BARACK & MICHELLE OBAMA
ACADEMY

DESIGN COMMITTEE MEETING #1

ATLANTA
PUBLIC
SCHOOLS

Existing **Main** Level Floor Plan

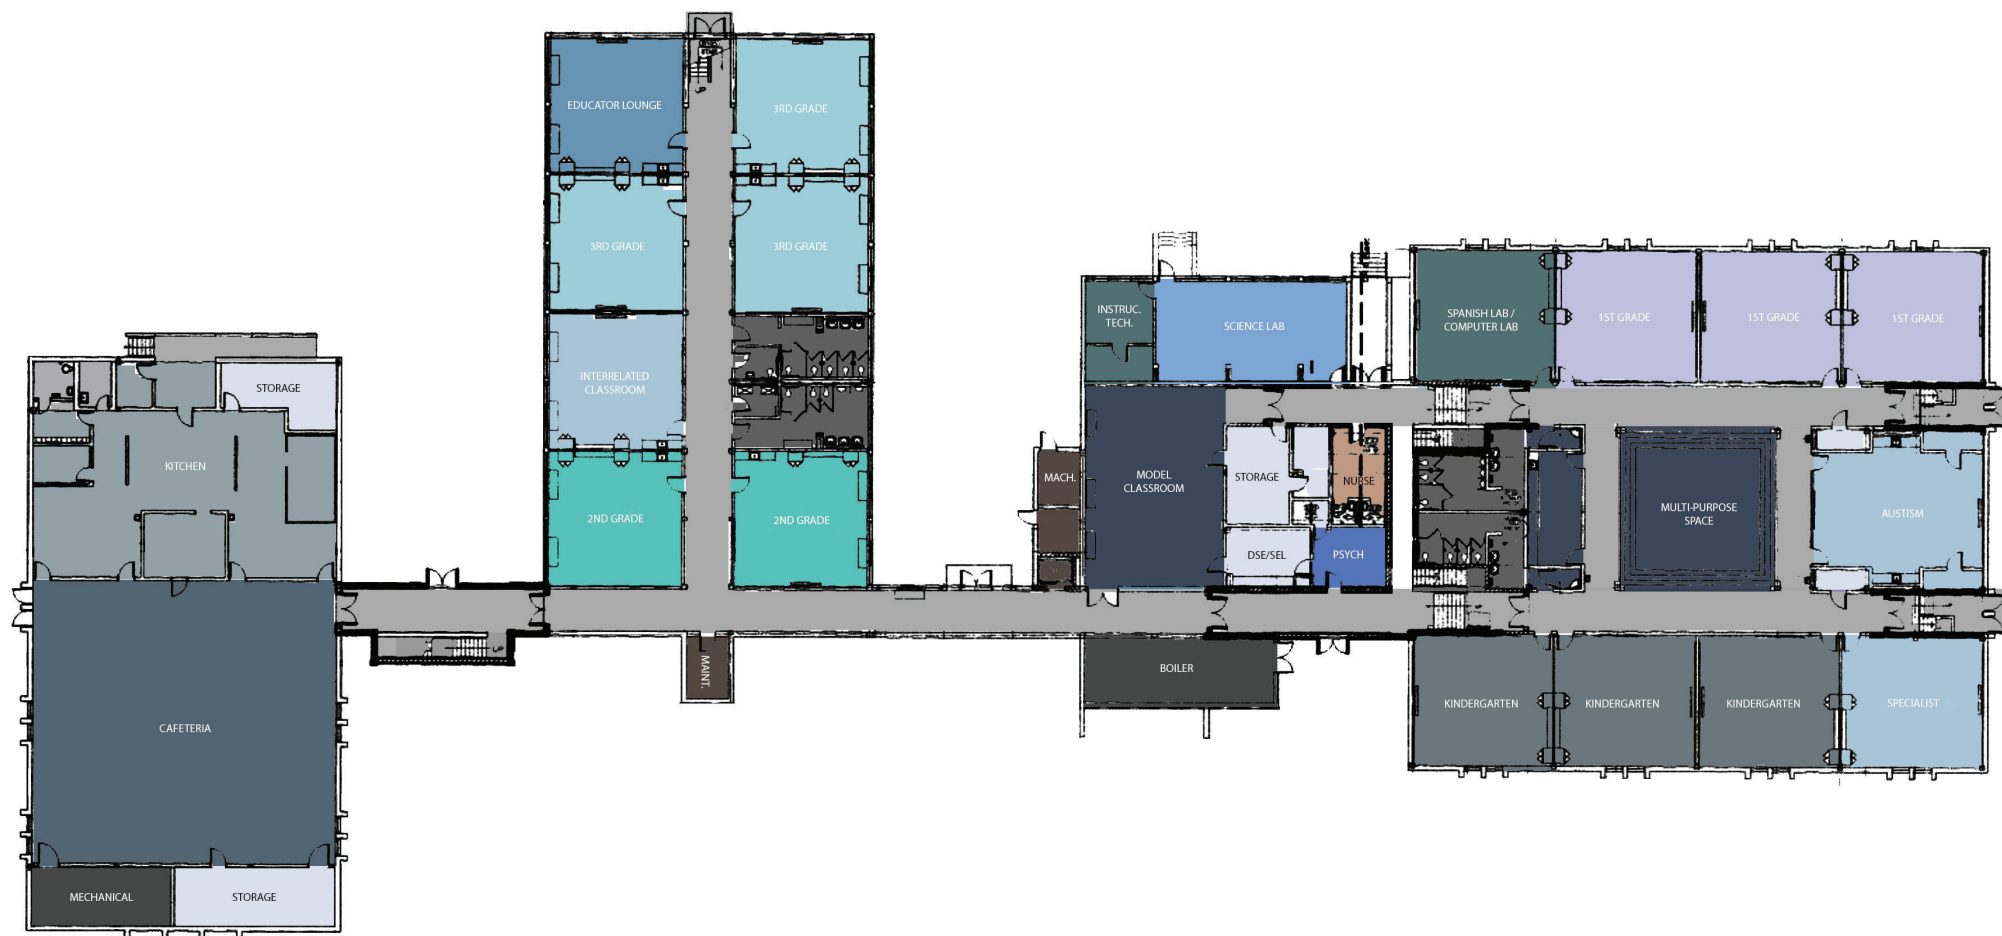
1. Roof needs replacing
2. Administration Suite is disjointed and undersized, clinic, mailboxes and time clock remotely located
3. ADA access at the gym level needs to be reviewed

4. All lifts (stair and platform) need to be replaced
5. Millwork updates are recommended, countertops replacement, sink and hardware repairs
6. IT cart storage for each classroom needs to be reviewed

7. Analog clocks to be upgraded to APS standard Digital system
8. Exterior of building to be cleaned and repainted, eyebrows to be repaired
9. Teaching wall in classrooms need to be reconfigured

10. Switches and outlets need to be replaced
11. Lighting and sensors need to be upgraded throughout
12. All handrails need to be replaced with stainless steel units and brought up to ADA standards

13. Entry courtyard planting and configuration to be reviewed
14. Stairwell widths need to be evaluated with occupant loads for adequate widths
15. Dryer not properly vented.

16. Faculty restrooms need to be evaluated for adequacy and ADA standards
17. Computer lab needs to be brought up to APS standards
18. Courtyard adjacent to the cafeteria is a safety concern, no visual from parking lot or street

19. Vestibule at entry from Sheltering Arms facility is not present
20. Security vestibule at main entry is not present
21. Floor finishes not up to current APS standards

22. Drinking fountains not up to current APS or ADA standards
23. HVAC balance and controls issues throughout the building
24. Sprinkler system not present on site

25. Security and intercom to be upgraded to APS standards
26. Missing card readers in several locations to be provided
27. Door hardware not to ADA standards in several locations

28. Doors to be repaired and /or replaced in many locations
29. Electrical capacity in each classroom and media center to be reviewed; currently only one outlet on exterior walls

30. Curb appeal to be reviewed
31. Many classrooms being used as offices, to be brought back to DOE usage where possible
32. Recommend adding exterior windows at interior spaces, where feasible, art, media

33. Generator not present on site
34. Wall mounted TV to be removed, locations for replacement to be reviewed with technology department
35. Wiring in trees and on building face to be investigated.
